LOT GRADING REVIEW

LECCO RIDGE DEVELOPMENTS INC.

PROJ. No. 16-12 MUNICIPAL ADDRESS

LOT No. 280

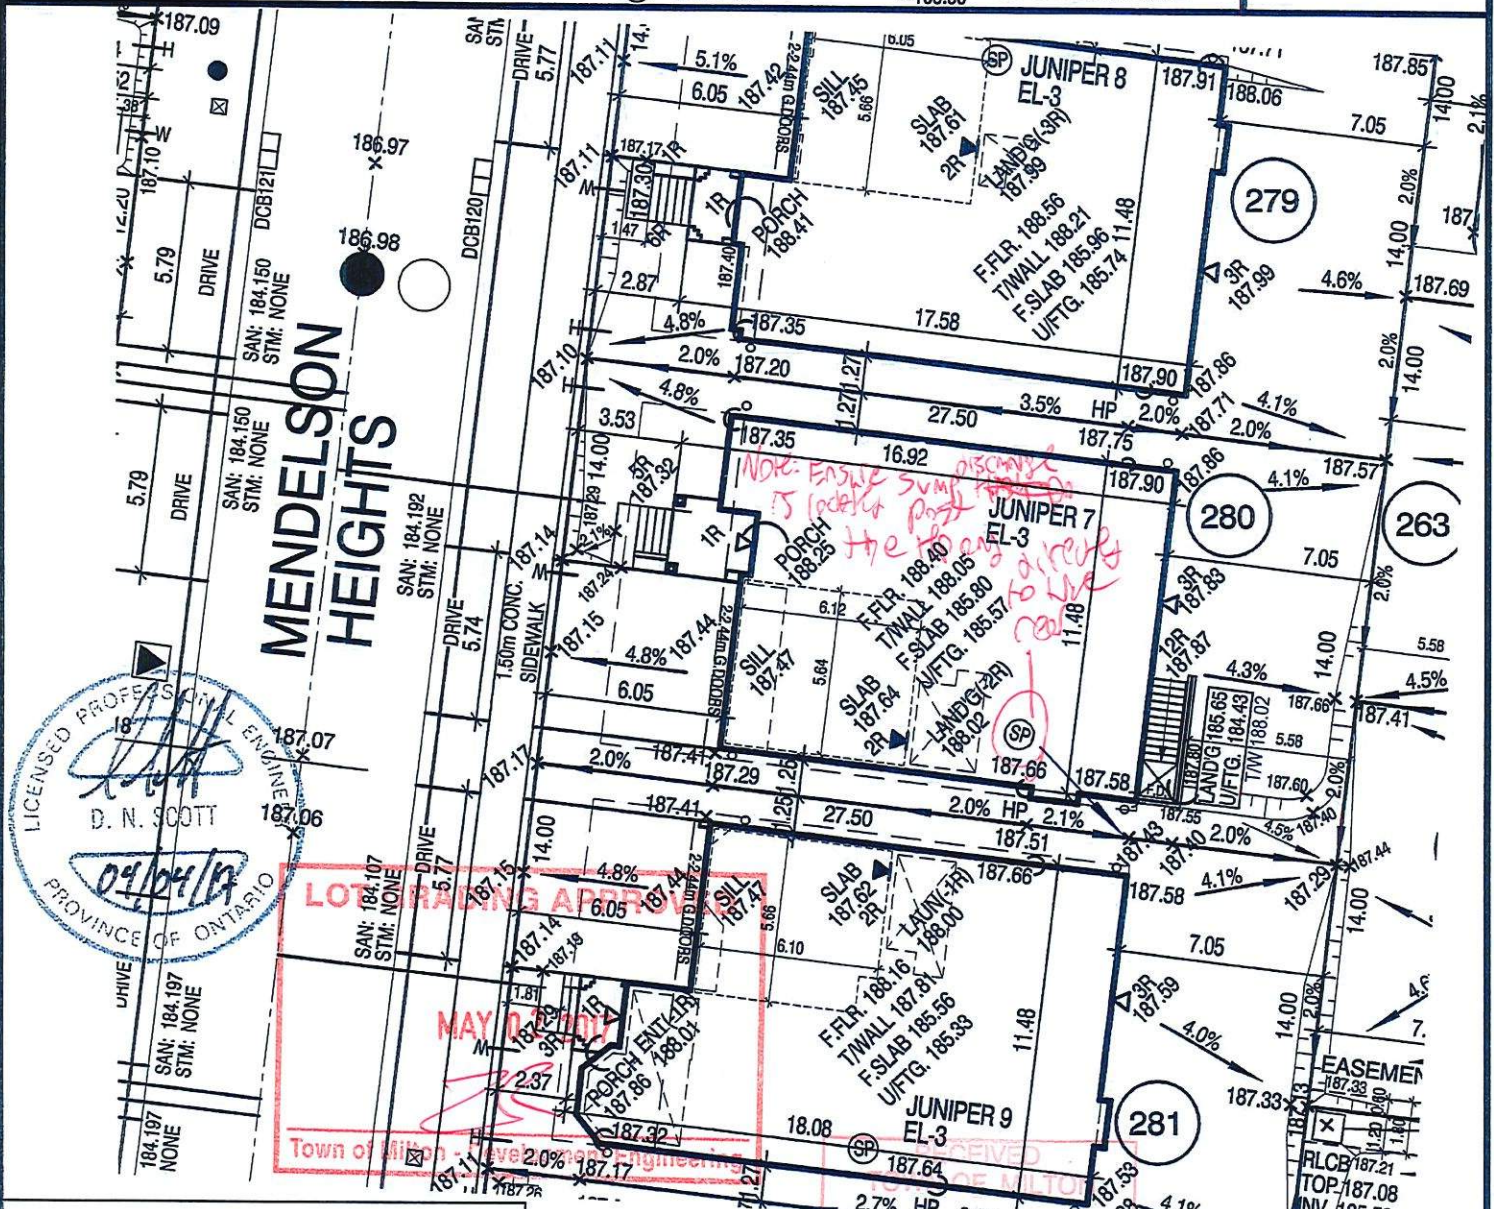
45 Min FRR

45 Min FRR w/NC Cladding

Guard/Handrail as per 9.8

Backfill height as per 9.15.

Siting to be read in conjunction with reviewed main model drawings

SUMP PUMP TO DISCHARGE TO REAR SPLASH PAD.

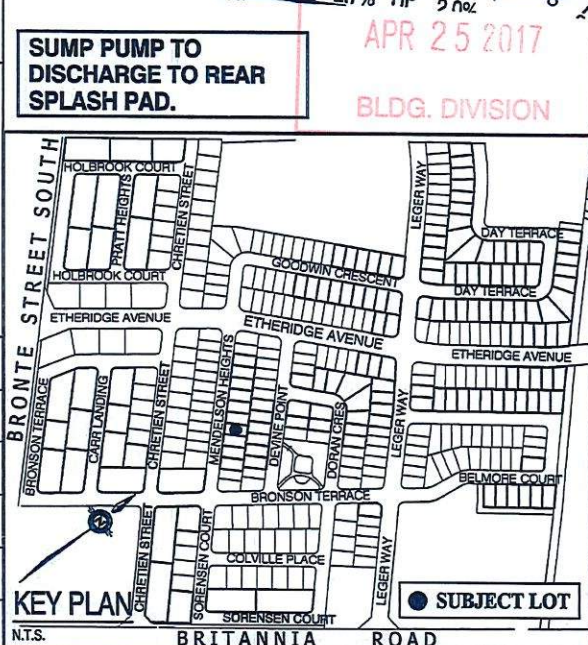
45 MINUTE RATED WALL WITH SIDE YARD < 1.2m
